## Technical product information

| <b>Topic</b>           | Seat belt presenter – Intermittent operation |
| <b>Brand</b>           | Bentley                                      |
| <b>Transaction No.</b> | 2034323/6                                    |

Figure 2

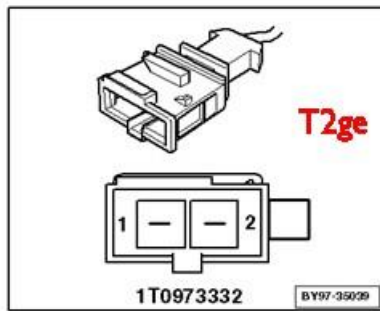
- Disconnect connector T2ge at the occupancy sensor (E31 Drivers, E32 Passengers). The 2 way connection can be identified by its blue connector housing located under the seat frame adjacent to the inboard seat runner (see Figure 2)

Figure 3

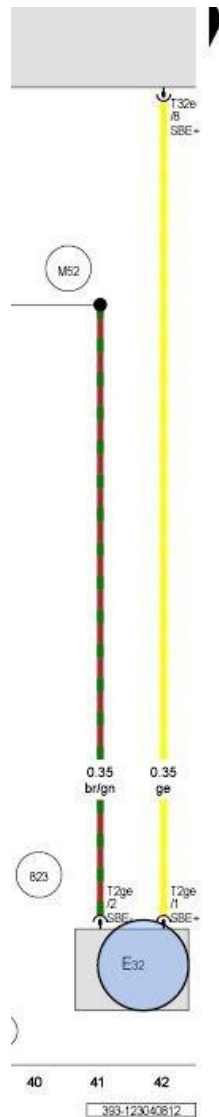
- With T2ge connector disconnected and an occupant sat in a natural position on the seat, with their back against the backrest, measure the resistance through the occupancy sensor (see Figure 3)

- If the resistance of the sensor with the seat occupied is greater than 90 Ohms then the sensor is faulty and should be replaced
- Once the occupancy sensor is known to function to specification (operation 2) then remove and discard the original seat adjustment control unit with memory (J136 Drivers, J521 passengers) and replace with the latest level part (part number 4W0.959.760)
  - The J136, J521 seat control unit is located under the seat frame reference workshop manual Rep. Gr. 72 Front seat control unit (J136, J521) – To remove and fit
